BP CHEMICALS, INC.
MIXED WASTE POND CLOSURE PROJECT

FIELD CHANGE REQUEST FORM

Field Change Number: 022 Date: 10/29/96

Subject: Anchor Trench wall edge repair

Client BILL LIMASubject ANCHOR TRACK REPAIR

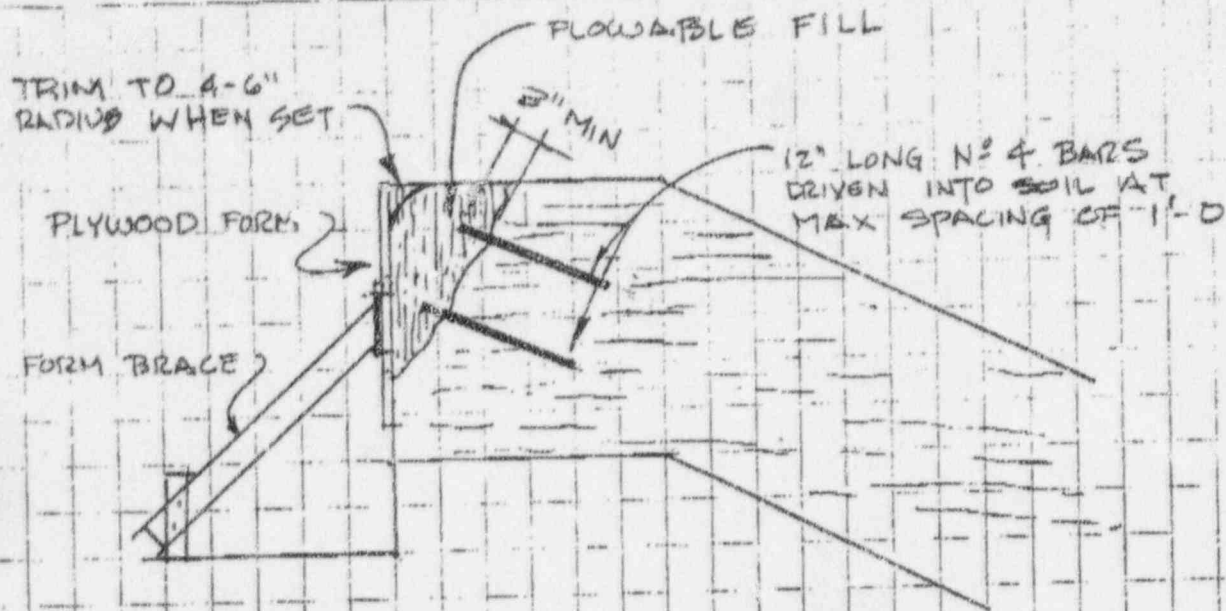
Description: provide a repair method using flowable fill concrete to restore
damaged edges of Anchor Trench sidewall.

Justification: 3' minimum runout length required with smooth edge to facilitate
proper installation of Geosynthetic Liner materials in Anchor Trench.

MIN. COMPRESSIVE STRENGTH = 50 PSI
FOR FLOWABLE FILL
